N-19082-RO-012 | PUMPING STATION STANDARDIZATION

ADMINISTRATION HVAC

ADMINISTRATION BUILDING - REV11 TERMINAL MOVES AND SHALLOW DUCT SIZE CHANGES

Rev11 is a roof-distribution proposal developed for the new 3.30 m clear-height requirement. Rev10 remains preserved as superseded for this ceiling constraint. These are engineering coordination proposals; final ceiling / OEM / pressure / structural approvals are pending.

DEEPEST DUCT ENVELOPE - NTS

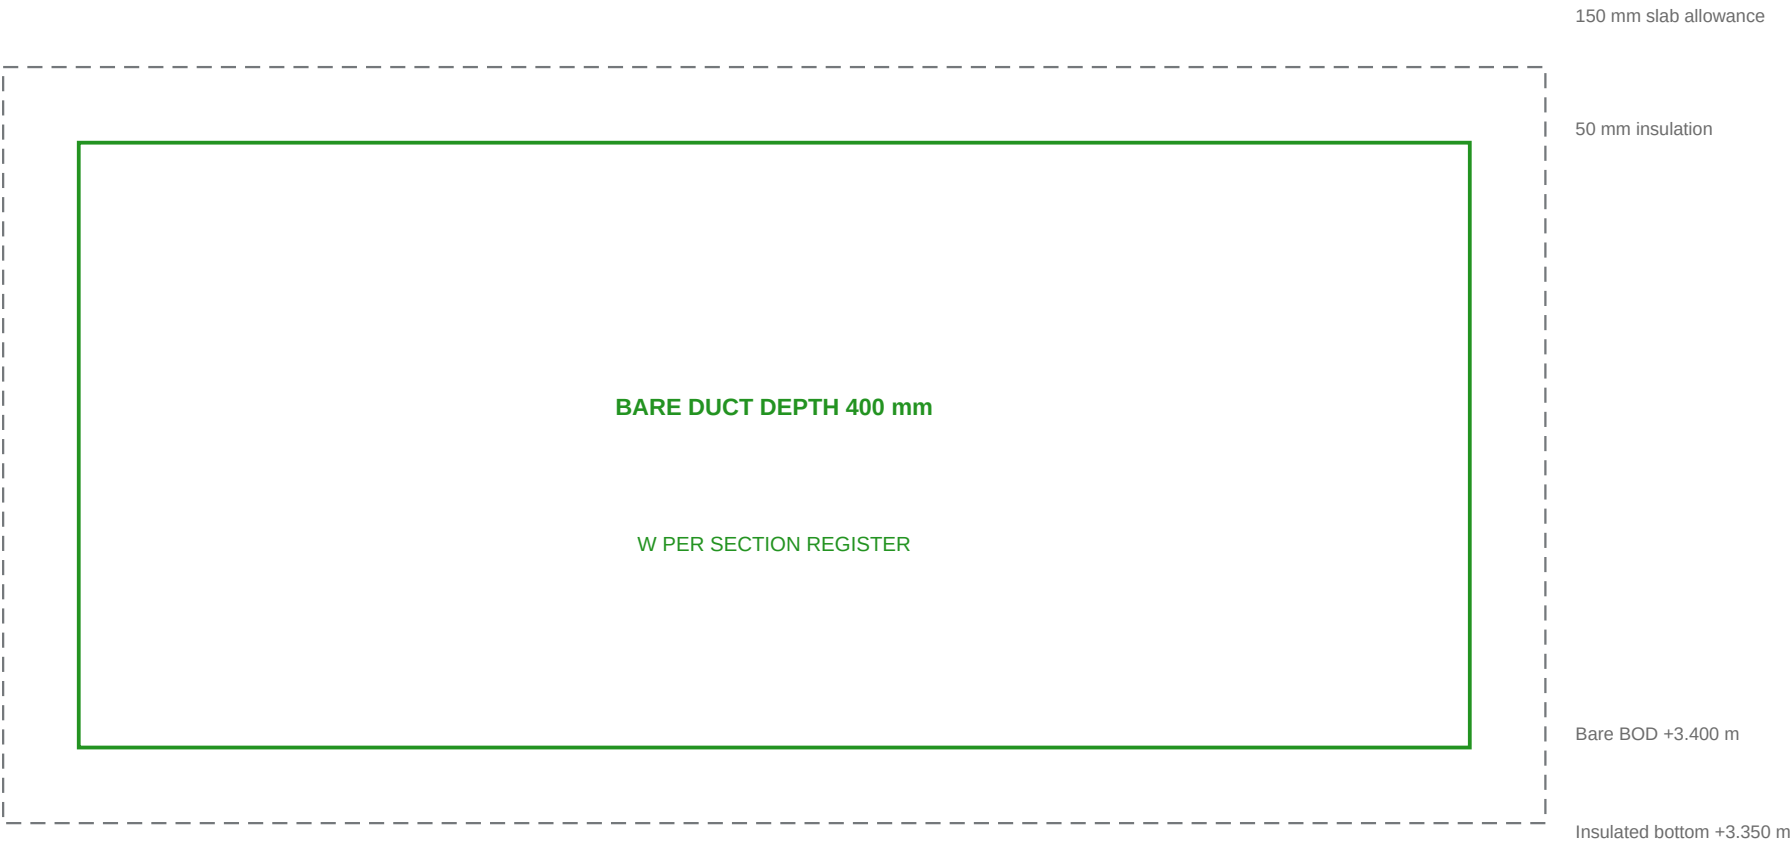
Deep common mains move to a proposed roof distribution system. Fifteen independent room supply / return drops replace the indoor common-main feeders.

Rev10 CX-08 had its lowest insulated bottom at +2.050 m, 1250 mm below this requirement. The Rev10 stacked arrangement is superseded by this roof option; it must not be installed at a 3.30 m ceiling.

Stack: 150 mm slab / support allowance + 50 mm insulation + 400 mm bare duct + 50 mm insulation + 50 mm ceiling gap = 700 mm.

The 50 mm gap below insulation is not a general maintenance clearance or a selected plenum dimension. Terminal drops / plenums must use the available connection space within the duct envelope; selected assemblies may require a local redesign.
